Addendum No. 003
9-090813A

DISTRICT – 2, Brick Building Restoration, Macon, Missouri

The following request for information contractor questions and the engineer's answers are incorporated as an addendum for all potential bidders to consider for their bids.

SOUTH ELEVATION

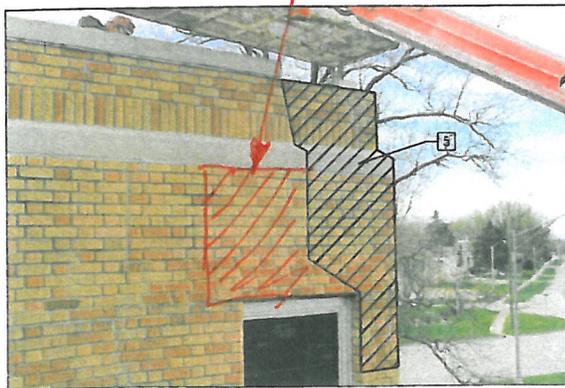
1. On drawings A201 on the south elevation none of the detail notes indicate that any of the window on the entire elevation gets re-caulked with the exception of window Type A. I have included a picture of a typical condition beneath and around the perimeter of the windows.
Per the attached drawing, remove the caulk from the perimeter of the two windows shown on the drawing and Recaulk the perimeter of the windows.
2. After the opportunity to see the pictures of the inspection opening above the 3 windows on the roof level, if given the opportunity I believe that we can fix that area above the window once and for good. Again there are pictures of this area as well.
Per the attached drawing, remove the additional brick shown on the drawing and reinstall per the original note. Upon removing the brick, install self-adhered flashing with end dams similar to detail 2/A501.

REMOVE CAULK FROM PERIMETER OF WINDOWS AND RECAULK

ADDITIONAL AMOUNT OF BRICK TO BE REMOVED AND REPLACED
